SAVANNAH HARBOR EXPANSION PROJECT CHATMAN  
COUNTY, GEORGIA AND JASPER COUNTY, SOUTH  
CAROLINA: FINAL GENERAL RE-EVALUATION RE-  
PORT AND ENVIRONMENTAL IMPACT STATEMENT  
JANUARY 2012

**ENVIRONMENTAL IMPACT STATEMENT**  
**APPENDIX A: Comments Received**  
**During Review of November 2010**  
**Draft EIS and Draft GRR**  
**SAVANNAH HARBOR EXPANSION PROJECT**  
Chatham County, Georgia and Jasper County, South Carolina

## Comments Received During Review of November 2010 Draft EIS and Draft GRR

**FIGURE 6-1:**  
**Savannah Draft vs Project**

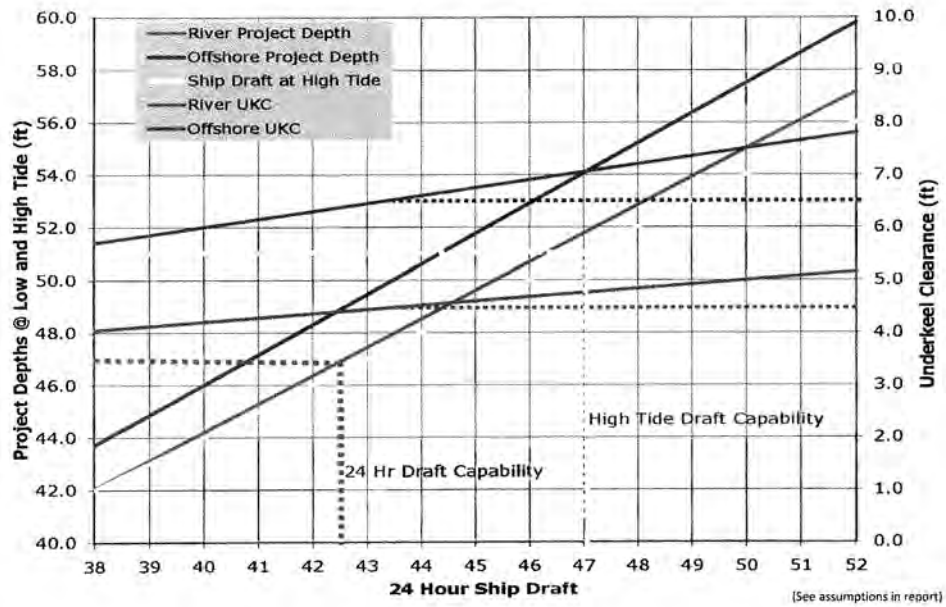
Figure 6-1 estimates draft and under keel clearance capability of various project depths at high and low tide for the Savannah River.

5. The result of the above assumptions is that an inbound ship will only be afforded 2/3 maximum tidal assistance at some point on their inbound voyage due to the duration of the voyage and the tide lag from the sea buoy to the terminal, and 1/3 of maximum tidal assistance on outbound voyages. The location of the ship at high tide, the speed of the ship, the length of a particular voyage within the project channel, and the actual tide range on a given day, determine actual tide assistance. The gross average of all these factors based on the above assumptions is 3 1/3 feet average benefit of high tide. For the purposes of this analysis, this has been rounded up to four feet, and therefore, this should be considered a liberal analysis, vice a conservative analysis. The USACE should report their findings and determinations on all of these factors and based economic projections on actual ship drafts this project can accommodate within Army Corps channel design standards.

**FIGURE 6-1:**  
**Savannah Draft vs Project**

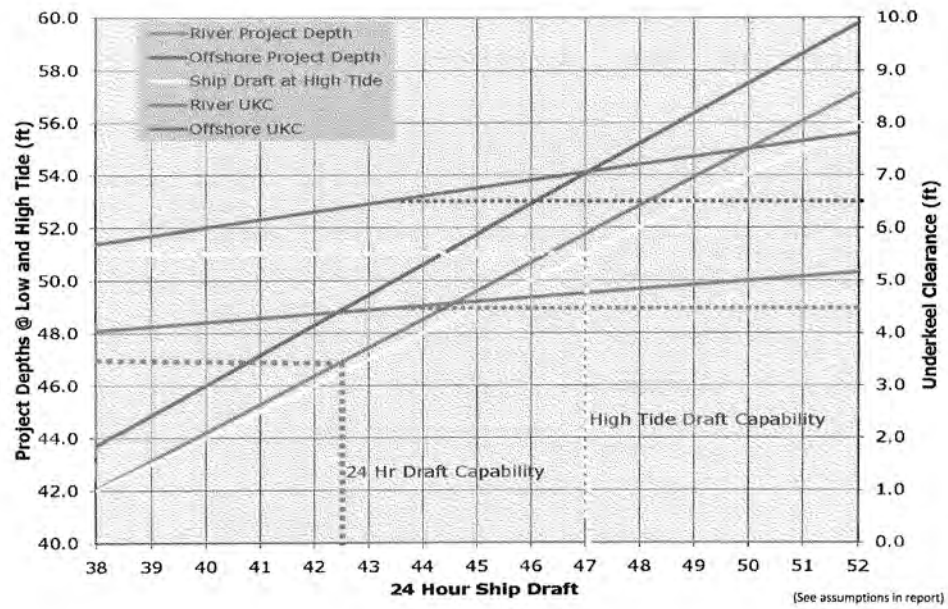
Figure 6-1 estimates draft and under keel clearance capability of various project depths at high and low tide for the Savannah River.

5. The result of the above assumptions is that an inbound ship will only be afforded 2/3 maximum tidal assistance at some point on their inbound voyage due to the duration of the voyage and the tide lag from the sea buoy to the terminal, and 1/3 of maximum tidal assistance on outbound voyages. The location of the ship at high tide, the speed of the ship, the length of a particular voyage within the project channel, and the actual tide range on a given day, determine actual tide assistance. The gross average of all these factors based on the above assumptions is 3 1/3 feet average benefit of high tide. For the purposes of this analysis, this has been rounded up to four feet, and therefore, this should be considered a liberal analysis, vice a conservative analysis. The USACE should report their findings and determinations on all of these factors and based economic projections on actual ship drafts this project can accommodate within Army Corps channel design standards.

**FIGURE 6-1:**  
**Savannah Draft vs Project**

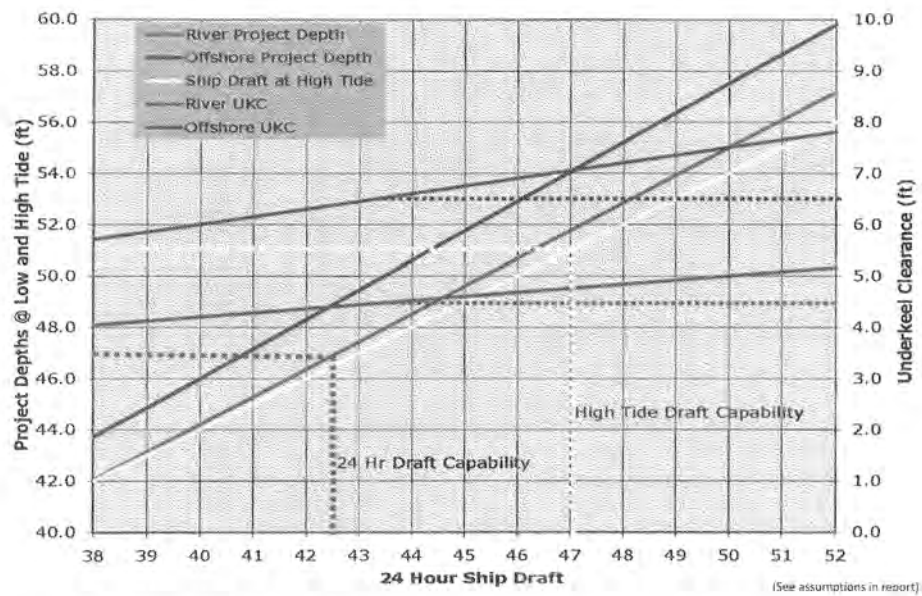
Comment:

**Response:** The graph does not include tidal lags and ranges; it only shows drafts and underkeel clearances that correspond to depths based on different h/T ratios. As noted, these h/T ratios are only designed to provide conceptual design guidance, not final designs based on detailed analysis using risk-based models and/or field or lab measurements.
